ST. MARYS COUNTY PUBLIC SCHOOLS

**SECURITY VESTIBULE
GREENVIEW KNOLLS ELEMENTARY SCHOOL**

ADDENDUM NO. ONE

MAY 6, 2009

SUBJECT: ROOF PLAN (A7/A121) - ADDENDUM #1
 PROJECT: GREENVIEW KNOLLS ES
 DATE: 05.06.09
 JOB NO: 28101.08
 SCALE: 1/8" = 1'-0"

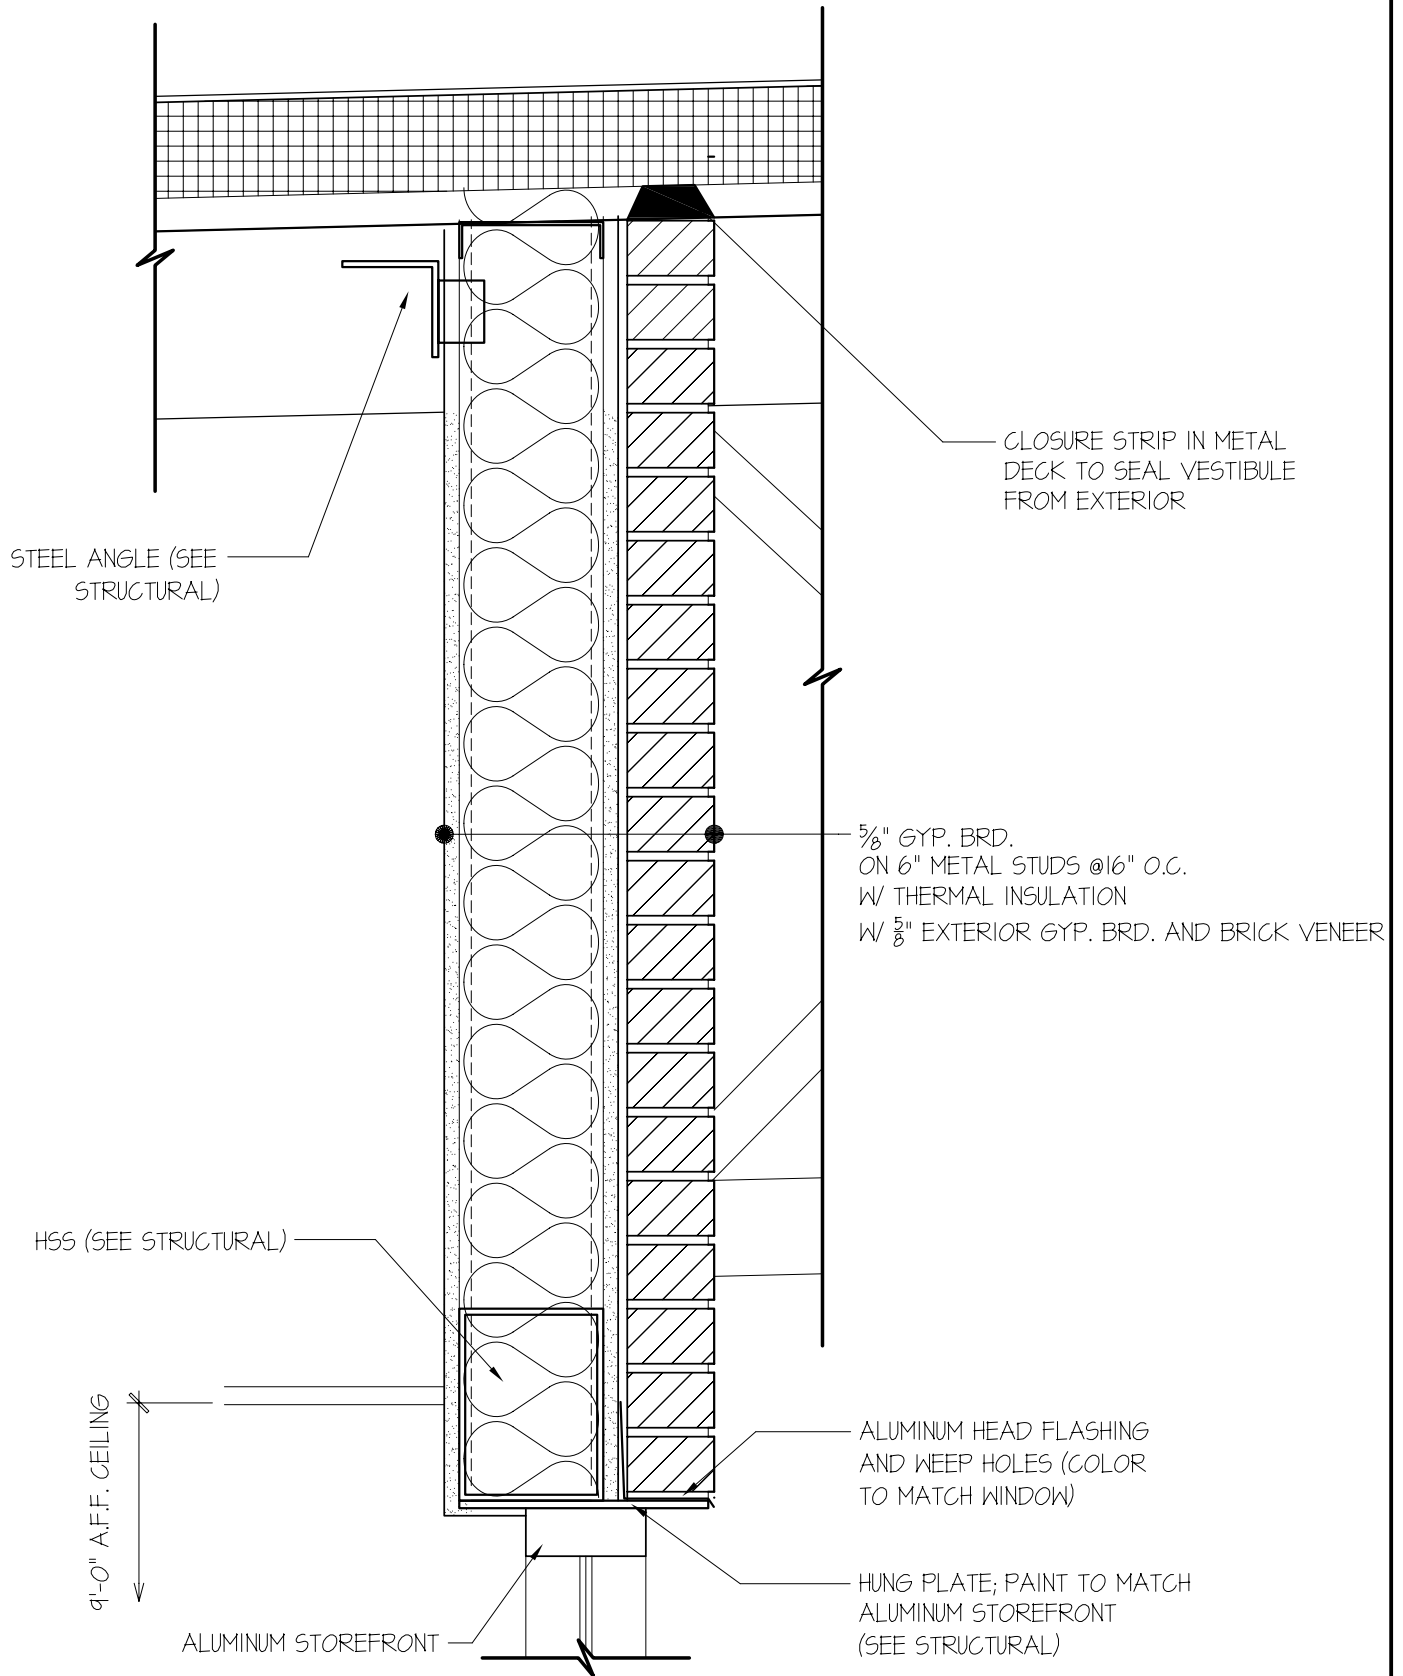
- B. A1/A201 references a cut A6/A501 that is not in the Drawings. Does this cut exist?
This callout should reference Detail A9/A501.
- C. F8/A201 shows parapet walls stopping at Column Line 3, while A7/A121 roof drawings shows parapet walls stopping between Column Line 3 & 4?
Please see revised roof plan A7/A121 included with Addendum #1 for the correct location of the parapet wall.

2. The following sketches clarify specific questions or discrepancies, and replace the details noted. The details are clouded with Revision #1, and are dated May 6, 2009:
 - a. **A7/A121 – New Roof Plan**
 - b. **C3/A502 – Section Detail over Storefront Entry**
